**SITE PLAN: LOT 316, PHASE 4,
THE PARKE AT OCEAN PINES, SECTION 16 OF OCEAN PINES
THIRD TAX DISTRICT, WORCESTER COUNTY, MARYLAND**

me
1/15/04
7/21/03 11/16/04
SFD w/ attached garage
BP# 86209
Swm# 86210

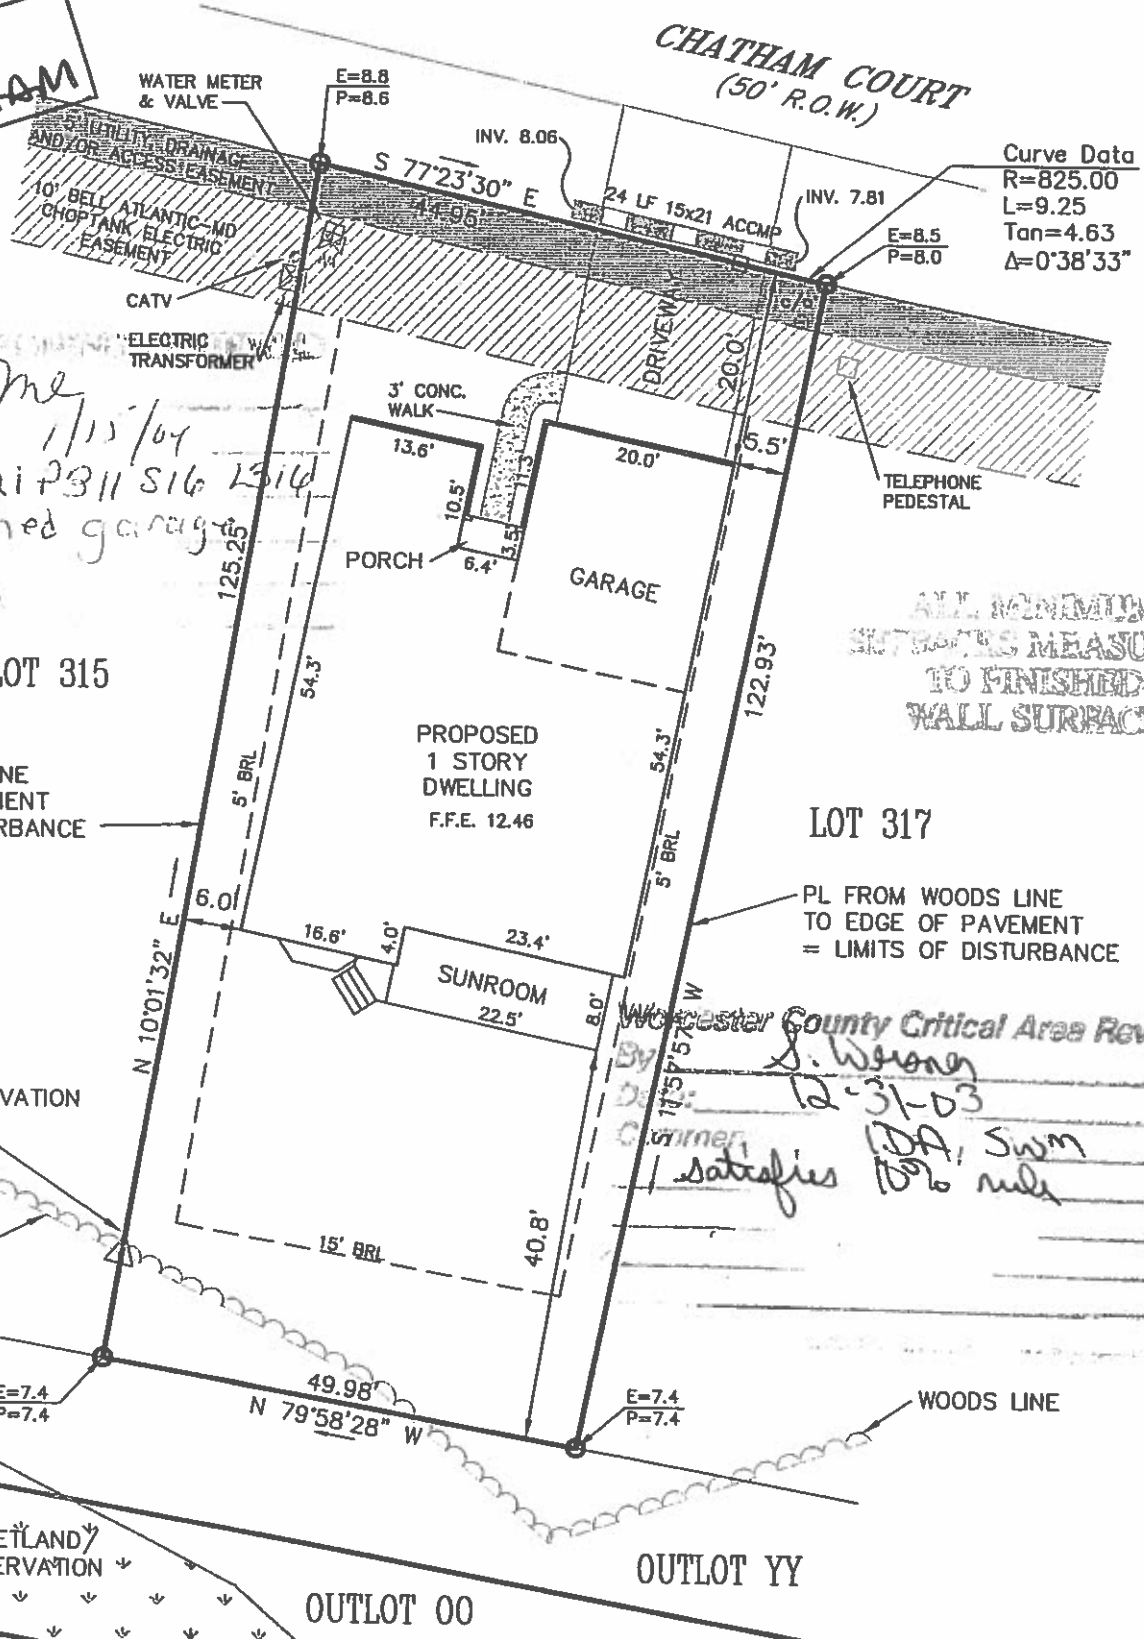
Worcester County Critical Area Reviewer
By: *J. Wilson*
Date: *12-31-03*
Comment: *1/2 DA, Swm / satisfies 10% rule*
